AGENDA
PLANNING AND ZONING COMMISSION MEETING
CITY OF CREVE COEUR, MISSOURI
MONDAY, NOVEMBER 18, 2013
7:00 PM

**CITY OF CREVE COEUR - MINUTES
PLANNING AND ZONING COMMISSION MEETING
MONDAY, NOVEMBER 4, 2013
7:00 P.M.**

APPLICATION TO PLANNING AND ZONING COMMISSION #13-019 FOR SITE CONCEPT AND SITE DEVELOPMENT PLAN APPROVAL OF A 25,653 SQ. FT. RETAIL GROCERY STORE, THE FRESH MARKET

SOUTH ELEVATION

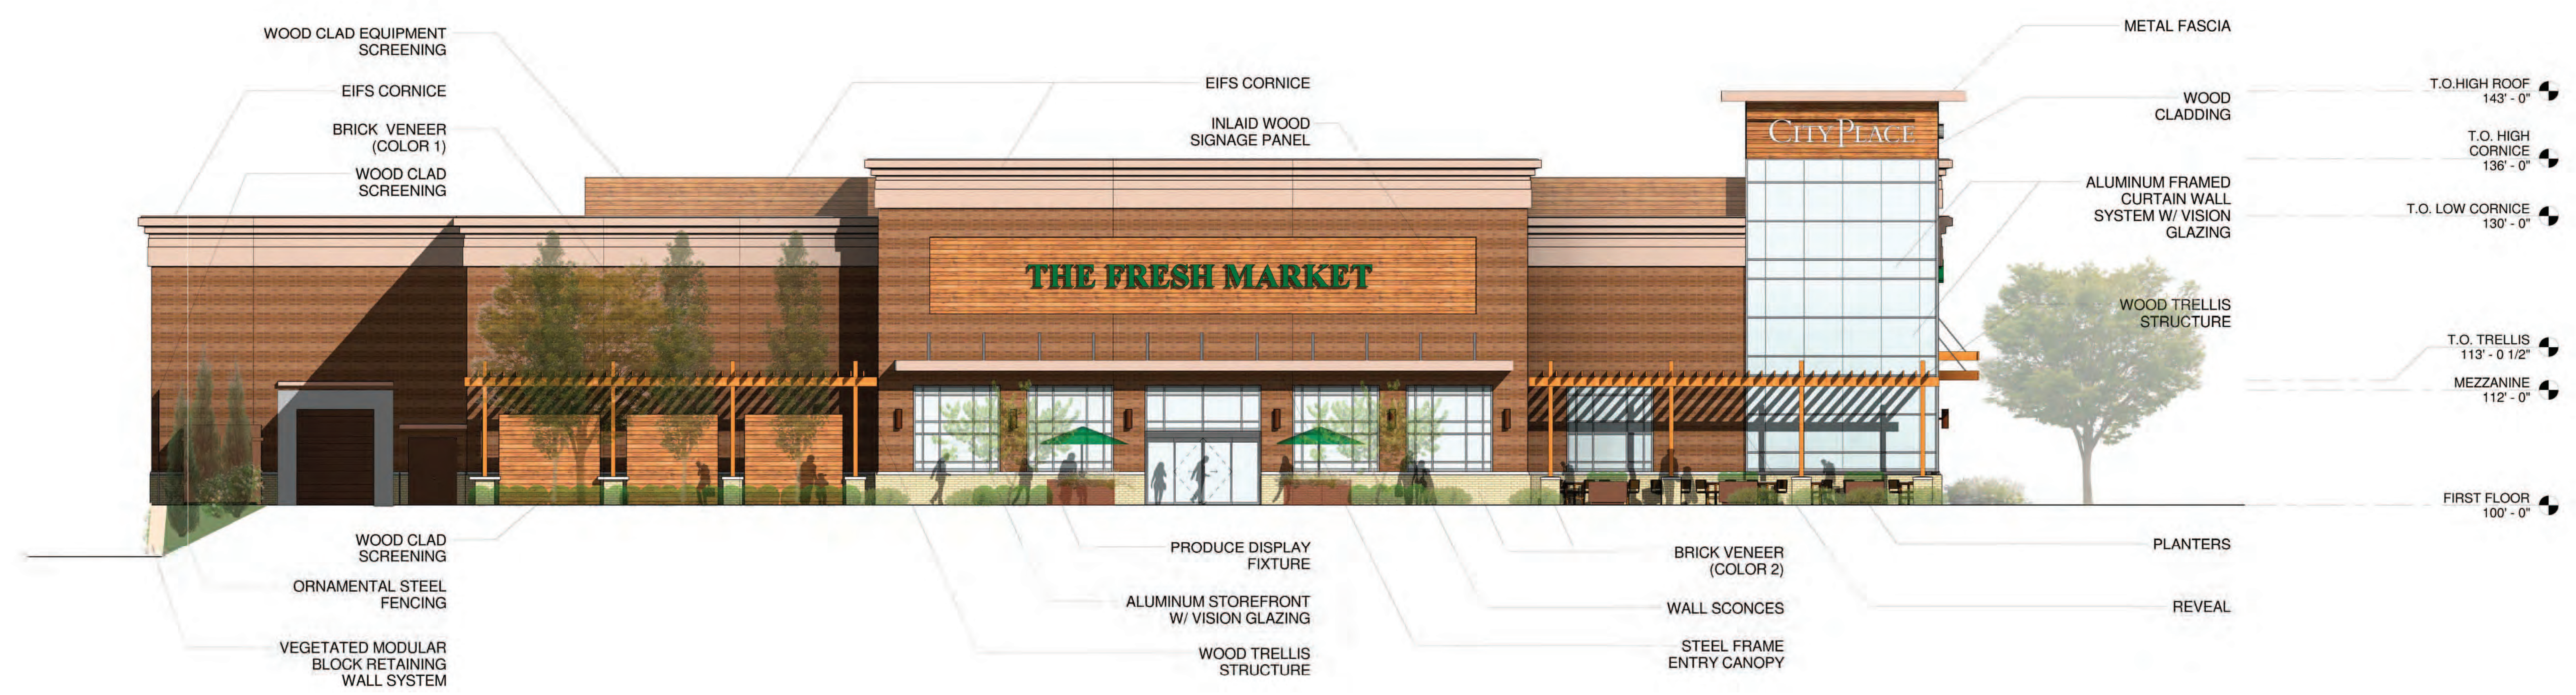
- a two-foot concrete apron has been added at the base of the south wall to improve the transition to the asphalt parking surface
- the pedestrian level of windows on the south façade are larger
- a set of arbors have been added that mimic those on the west façade
- the pattern of mullions on the windows is carried over from Cityplace 6;
- the canopy over the main entrance has been raised to allow more light and air at the entrance;
- the north half of the west façade is now used as a storage area for waste cardboard with several wood screens that are styled after the wood wall panels and mechanical screens;
- the tower element has a significant impact on the appearance of the south and west façades; and,
- the reveal line along the sides of the tower add visual identity to the tower.

NORTH ELEVATION

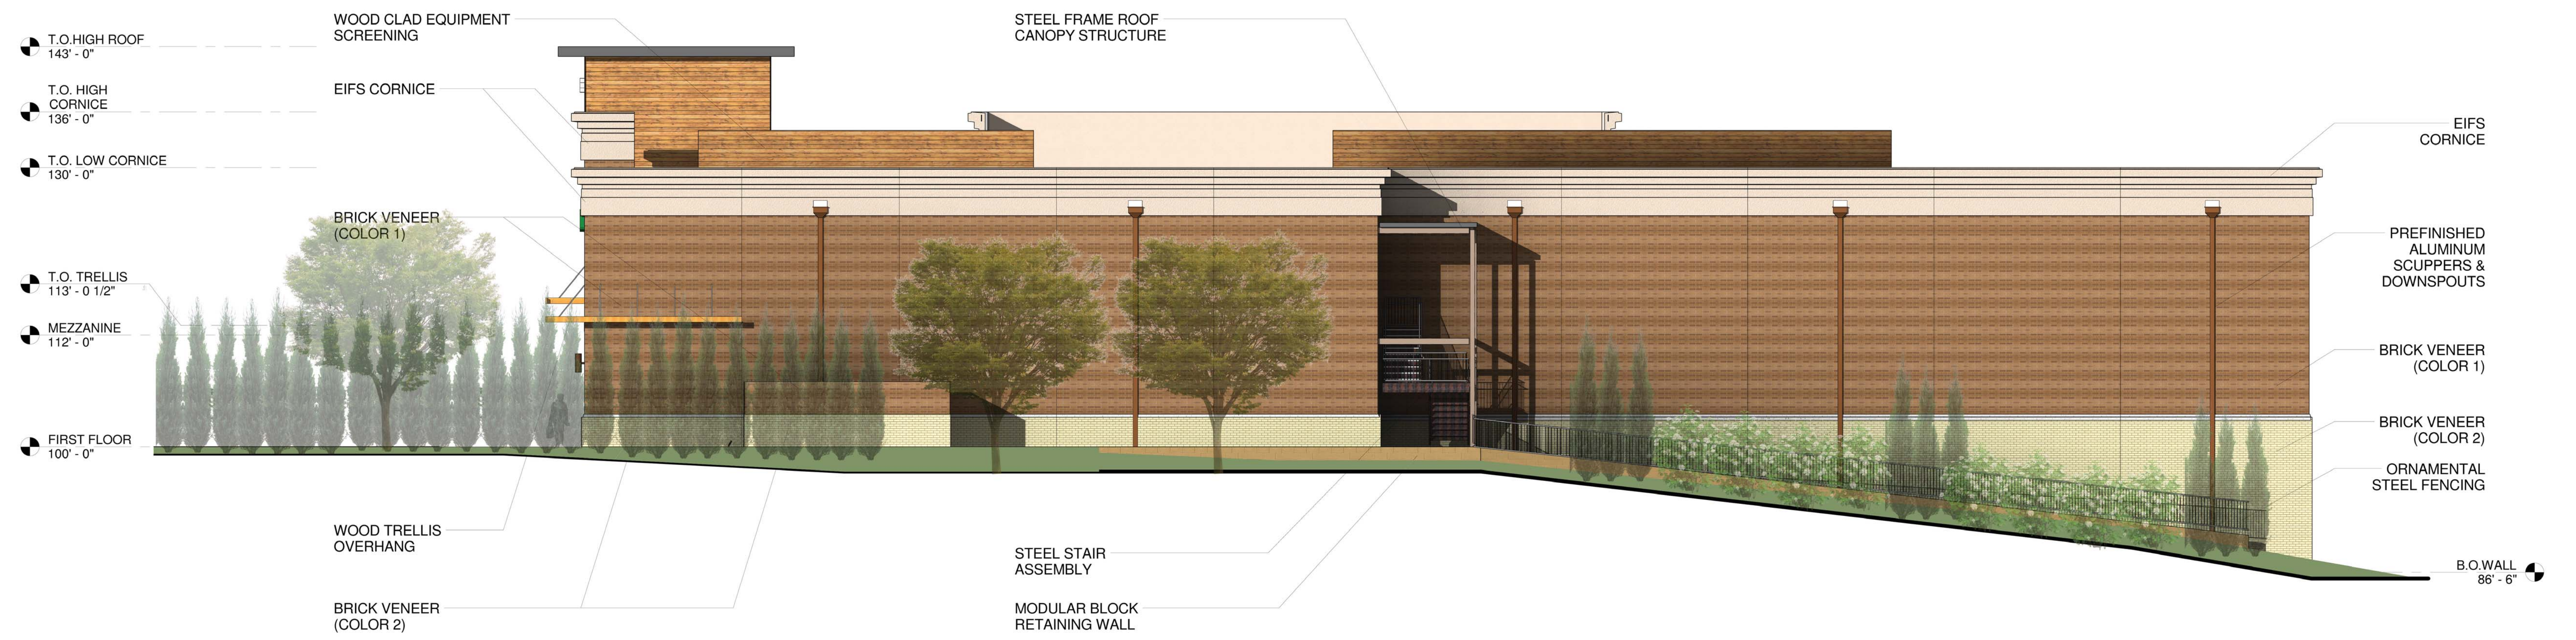
Figure 1: Note addition of loading dock screen wall, cardboard storage screen and enlarged rooftop mechanical screens.

The north side of the building (shown in Figure 1) was of particular concern for the Planning Commission and the applicant has responded by inserting a large screen wall of the same wood materials used elsewhere on the building to hide the compactor and loading dock from view from
